**Development Application DA2019/0332
Supplementary Statement of Environmental Effects
Amended plans and associated clause 4.6 variation request – Height of
buildings
Demolition and construction of shop top housing
55 Kalang Road, Elanora Heights**

- Amended architectural plans DA01(A) to DA06(A) prepared by RFA Architects;
- Views from the sun study videos; and
- Updated clause 4.6 variation in support of the proposed height of buildings variation (Attachment 1).

Figure 2 – Cross section extracts from Plan DA06(A) showing extent of building height breaches

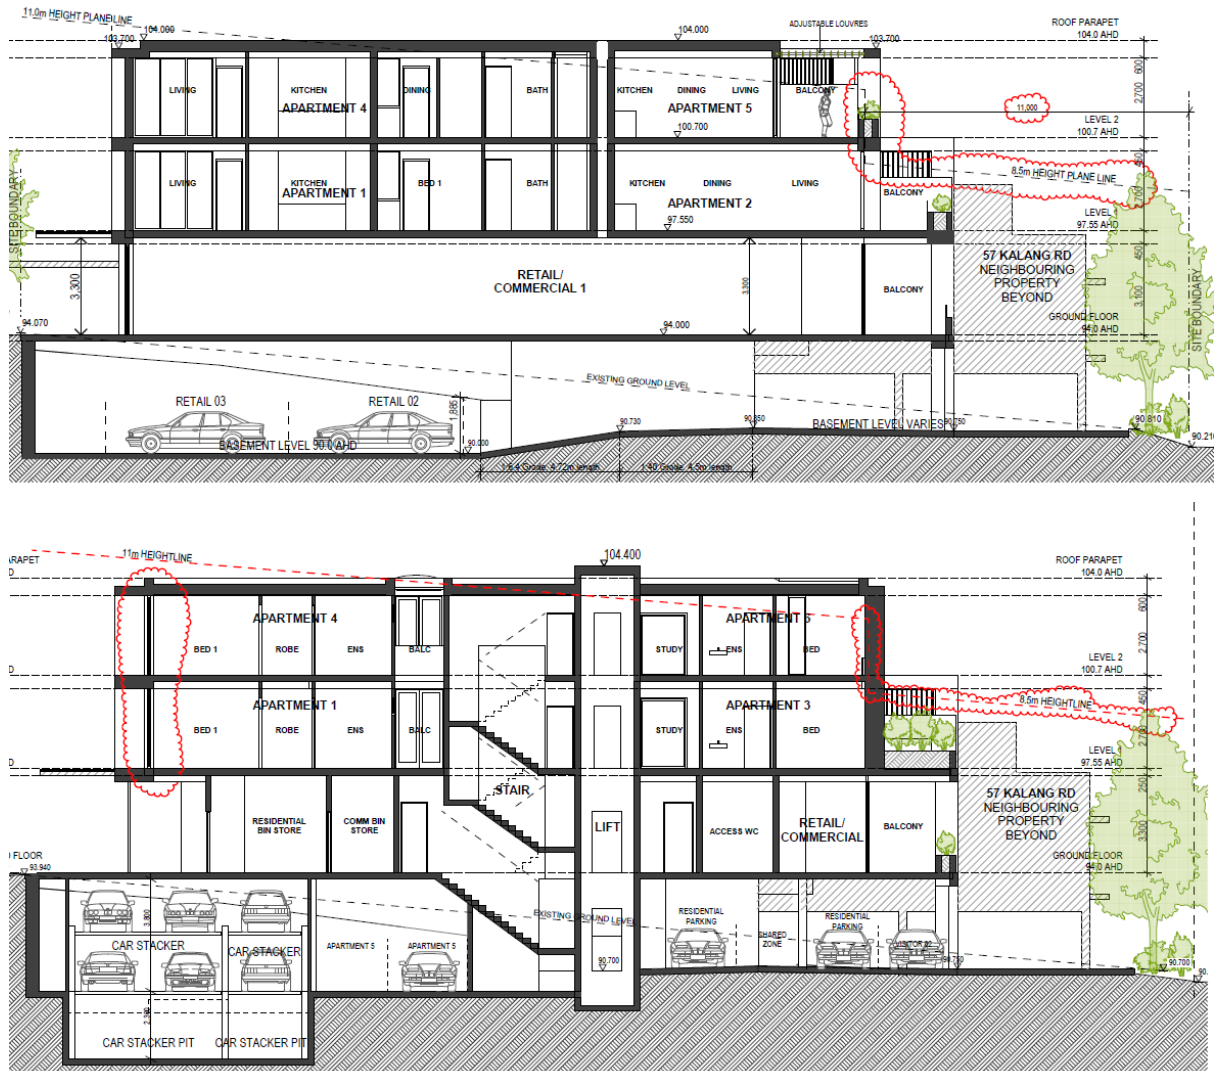
In relation to the portion of the development located within the 8.5 metre height subzone we confirm that the blade walls/ louvered privacy screens at either end of the Level 1 rear facing Apartments 2 and 3 balconies have a maximum height of 9.5 metres representing a non-compliance of 1 metre or 11.7%. We also confirm that whilst the Level 2 glazed façade alignment is located within the 11 metre height subzone that the Apartment 6 vertical balcony framing extends into the 8.5 metre height subzone resulting in a building element height of 12 metres representing a small partial non-compliant facade element intrusion of 3.5 metres or 41%.

In relation to the portion of the development located within the 11 metre height subzone we confirm that the rear portion of the development breaches the standard by a maximum of 1.2 metres or 10.9%. The extent of variation is depicted on plan DA06A an extracts of which are at Figure 2 below.
